PROPOSED IMPROVEMENT
BRIDGE PROJECT

TOWN OF WALDEN

ROUTE NO : VT 15 (MINOR ARTERIAL) BRIDGE NO : 83

PROJECT DESCRIPTION : REPLACEMENT OF BRIDGE 83 WITH RELATED APPROACH ROADWAY AND CHANNEL WORK

AS #1 Details

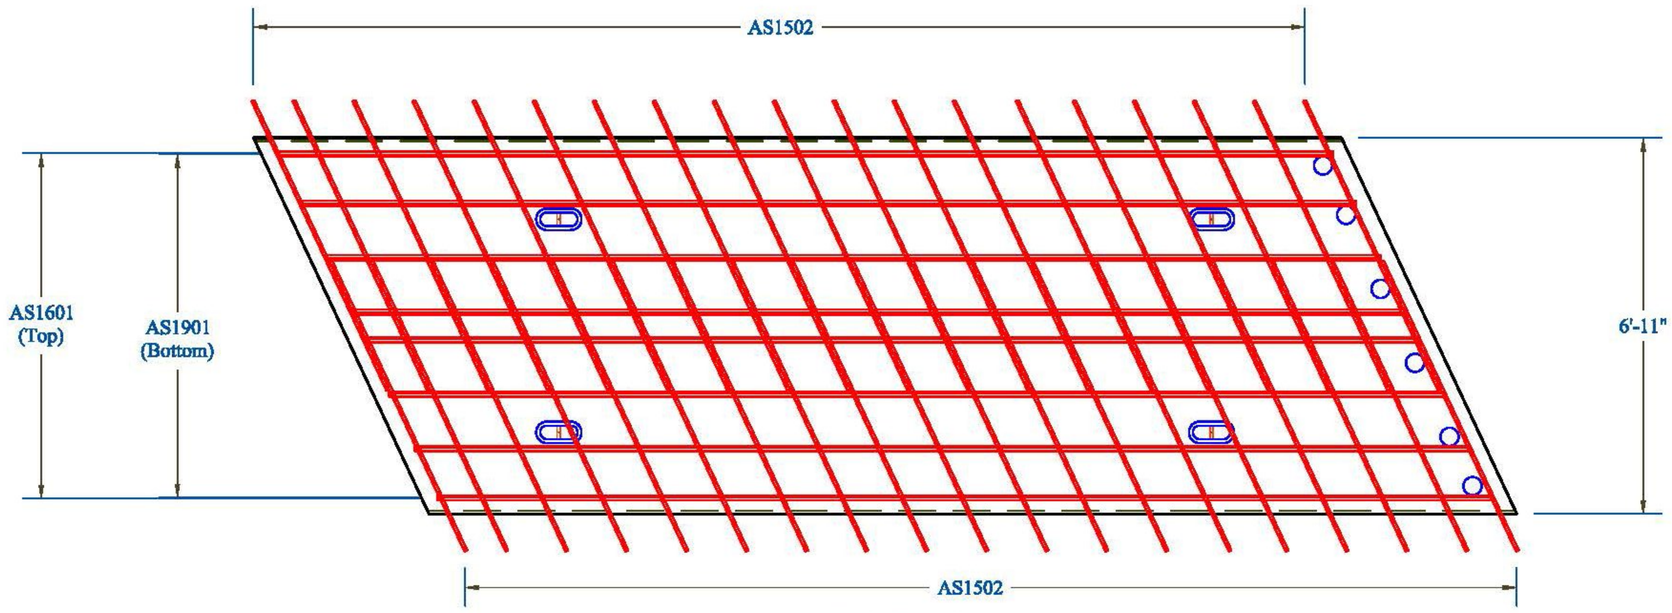
Check depth of lifting inserts to ensure they will not interfere with the rebar

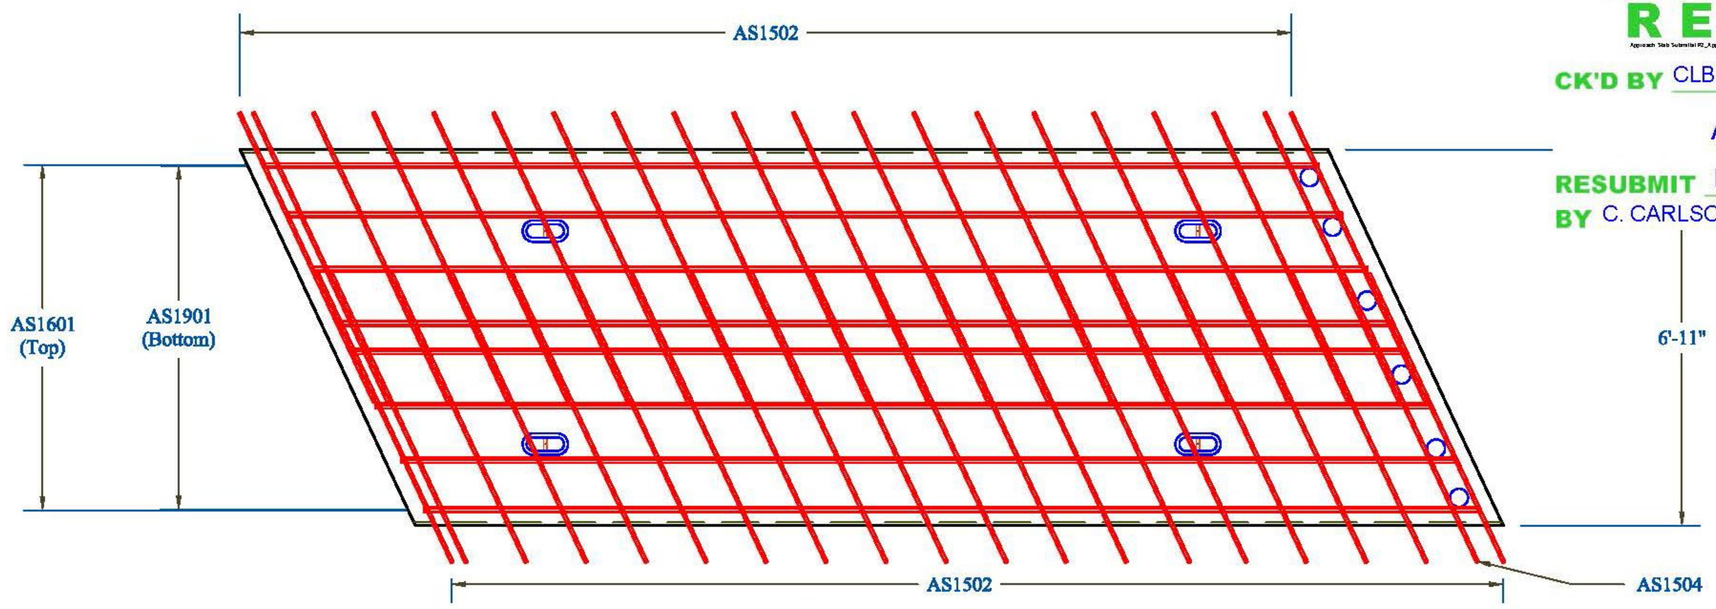
Check depth of lifting inserts to ensure they will not interfere with the rebar

Abutment 1: Plan View

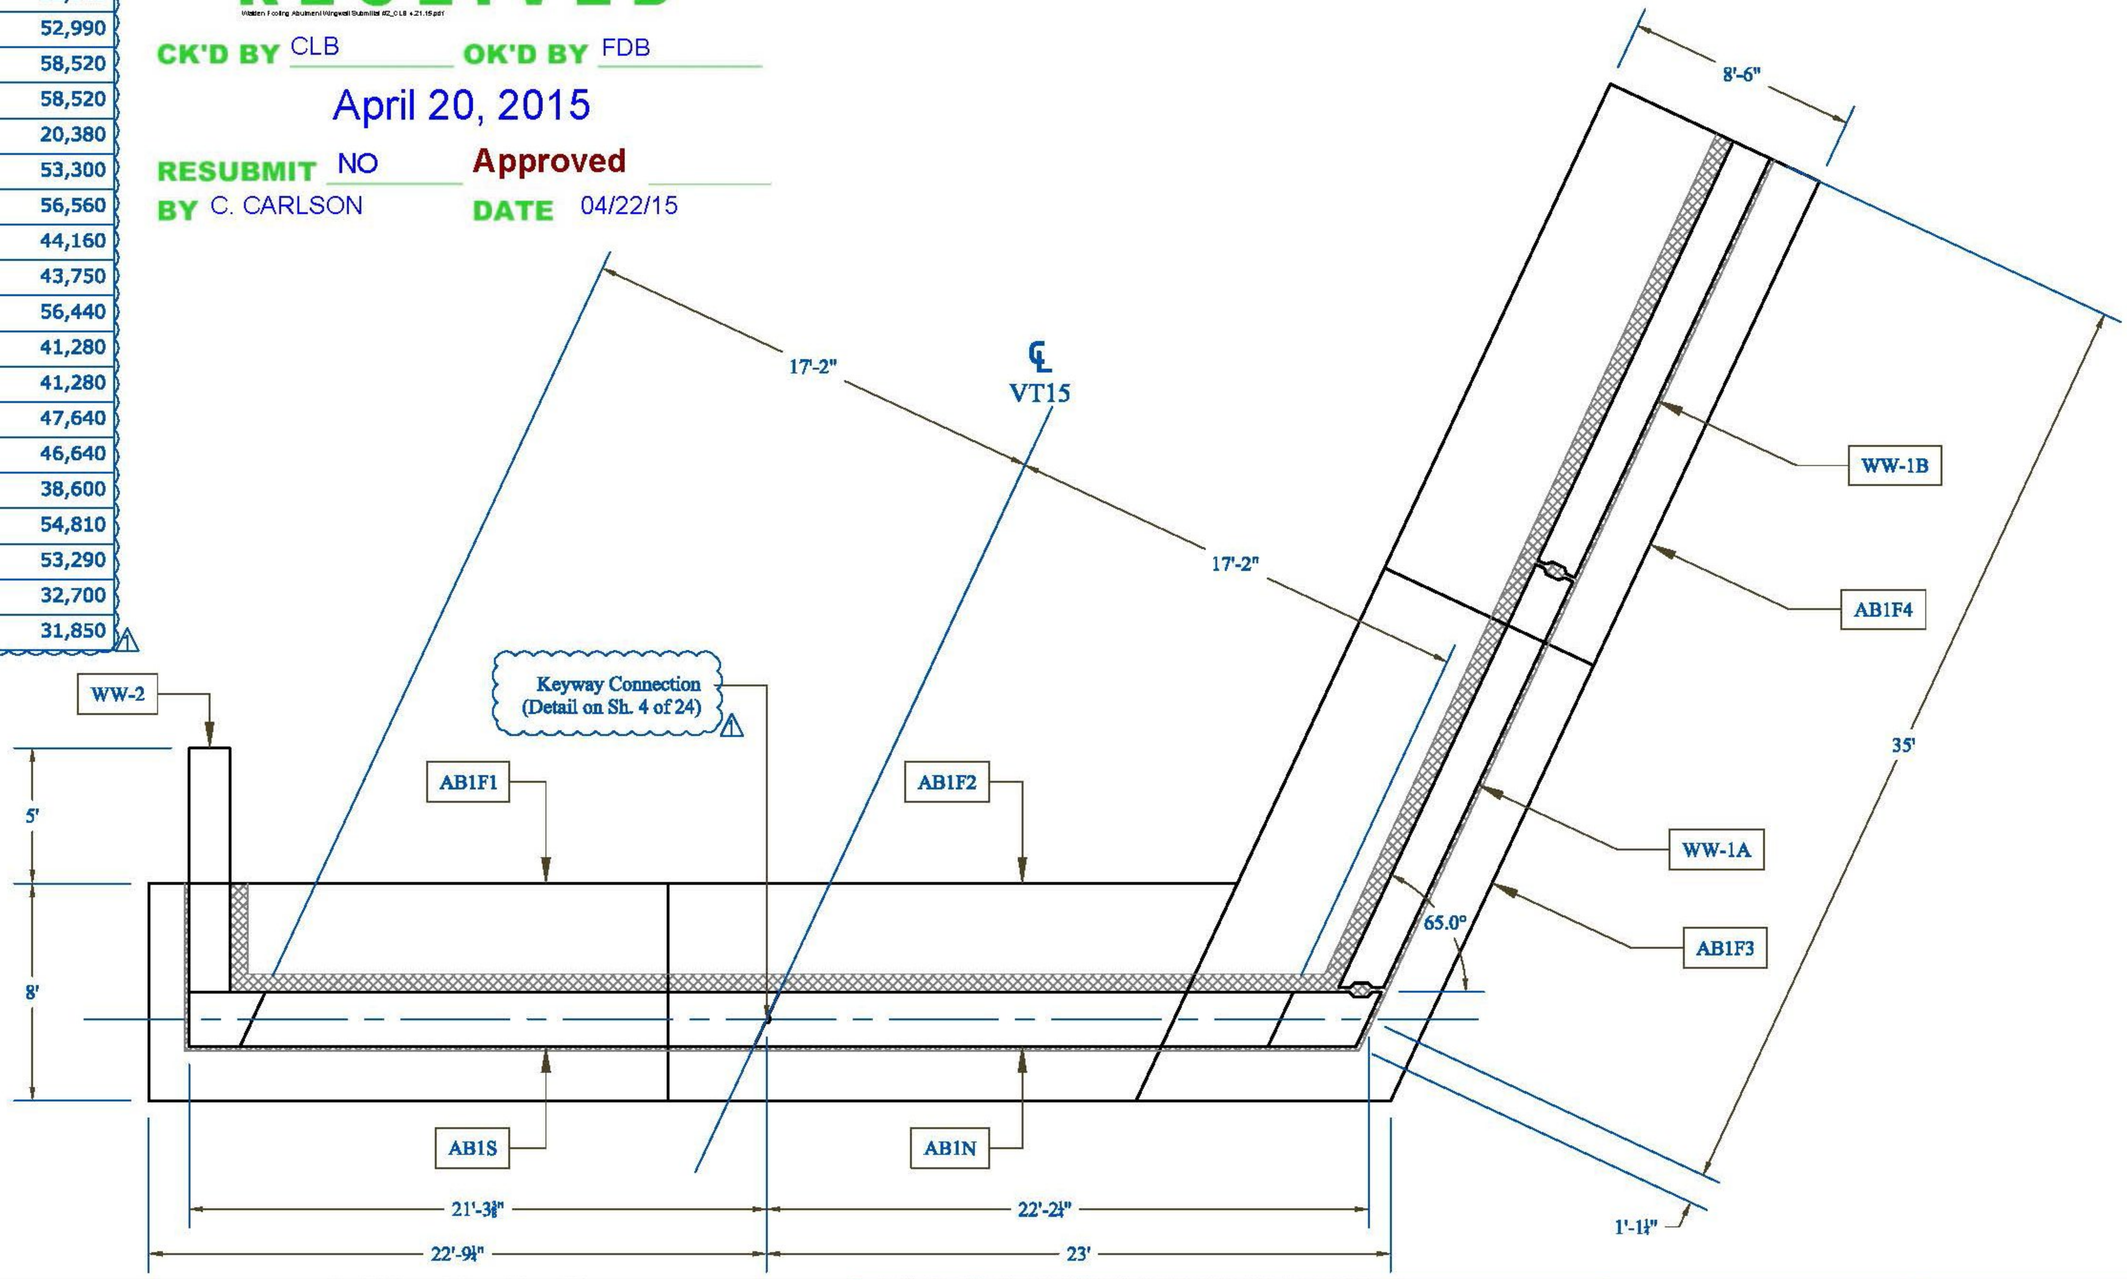
CONTRACTORS VISPE:	Rev.	Date	By	Description
	1	04/16/15	IBA	Changes per State Review

Abutment 2: Plan View

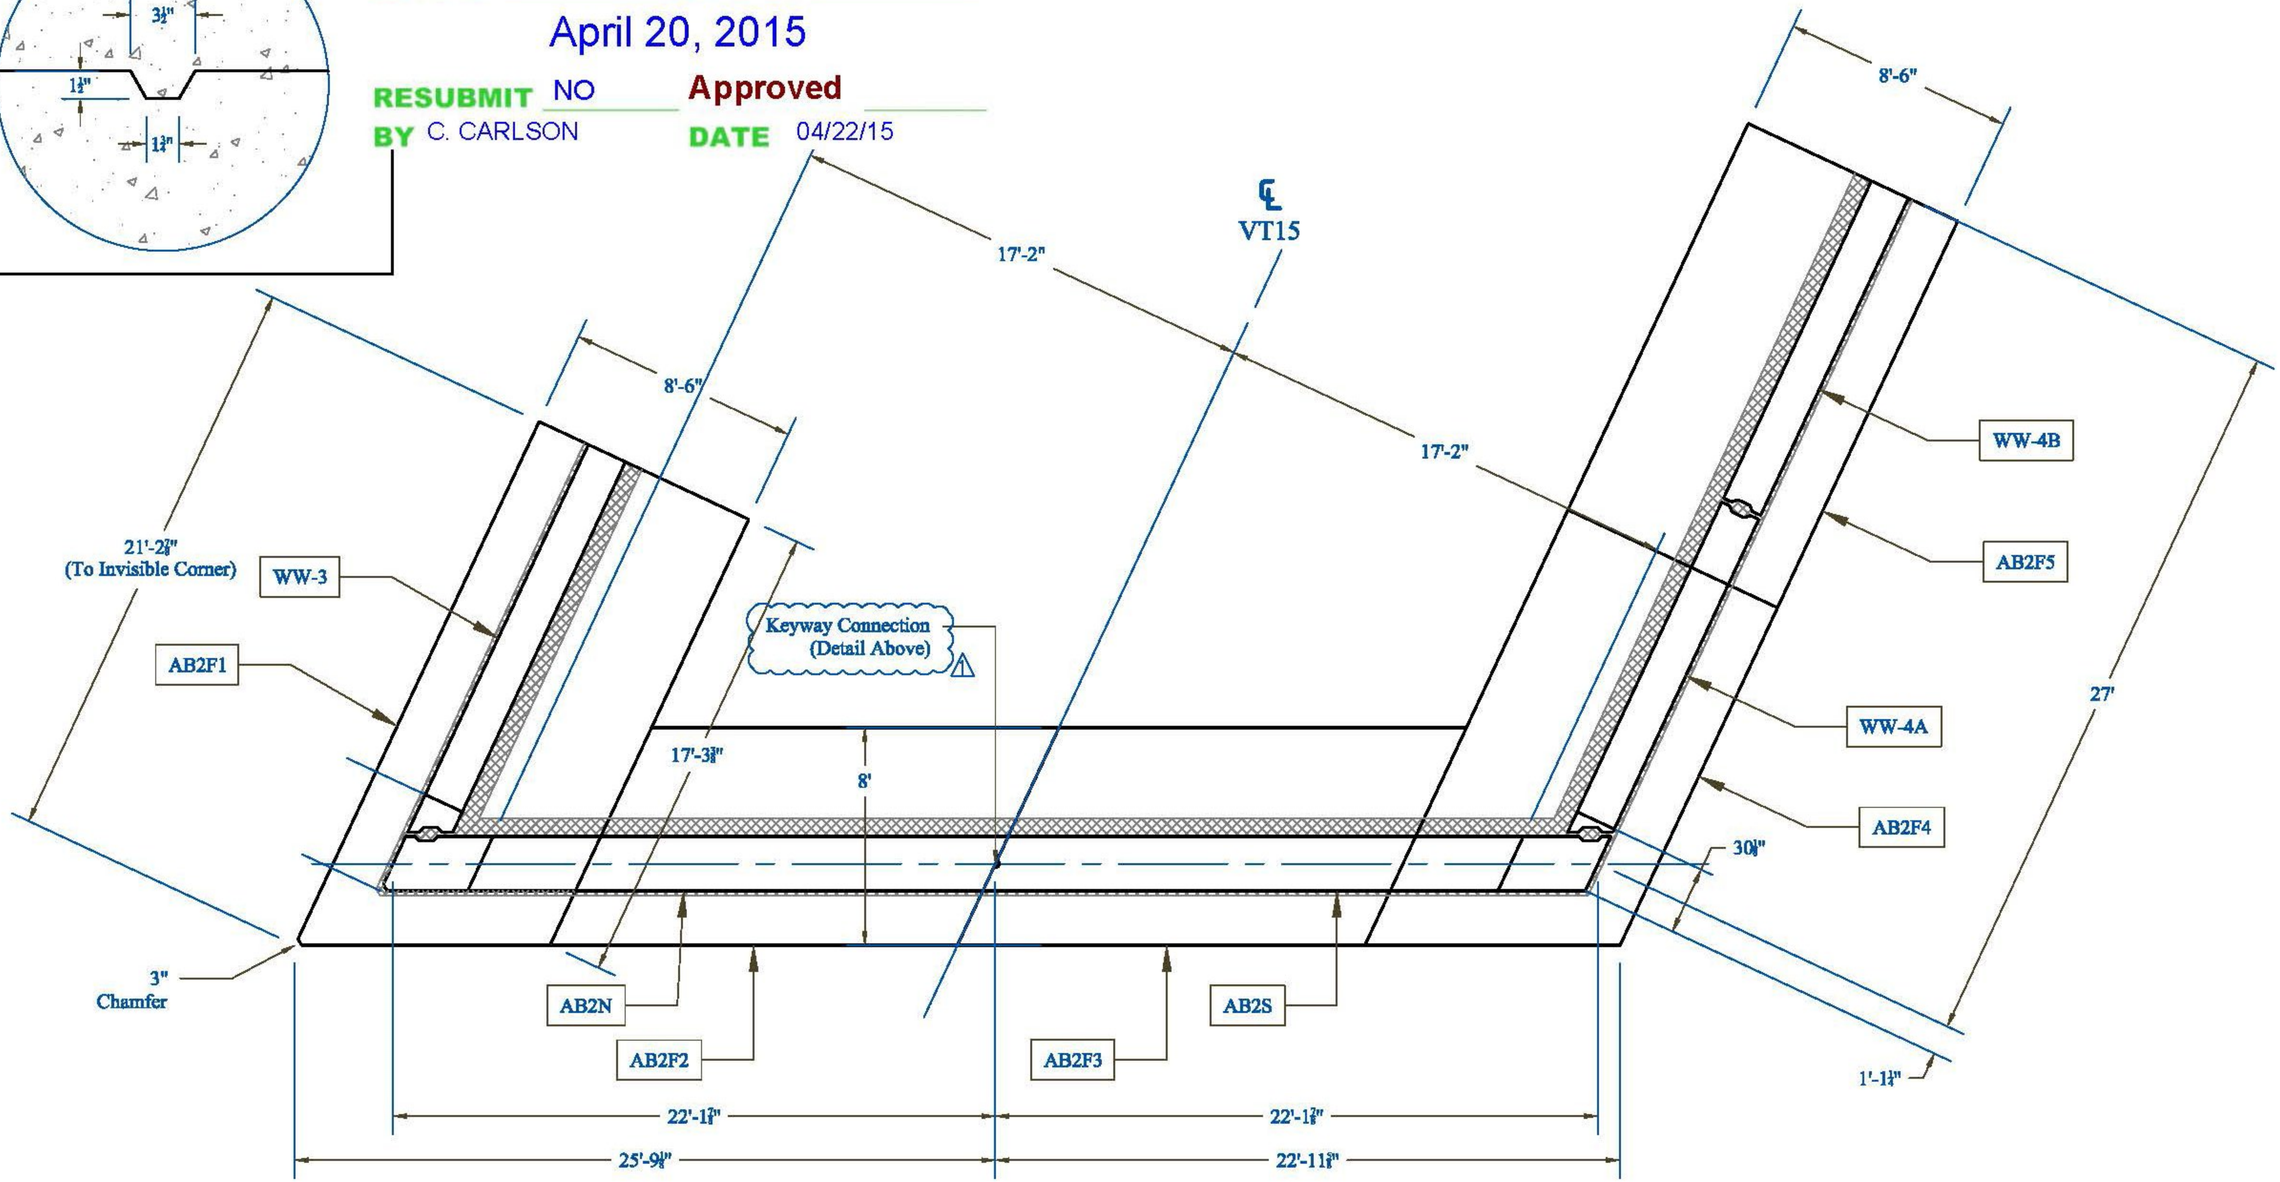
CONTRACTORS VISPEC	Rev.	Date	By	Description
	1	04/16/15	IBA	Changes per State Review
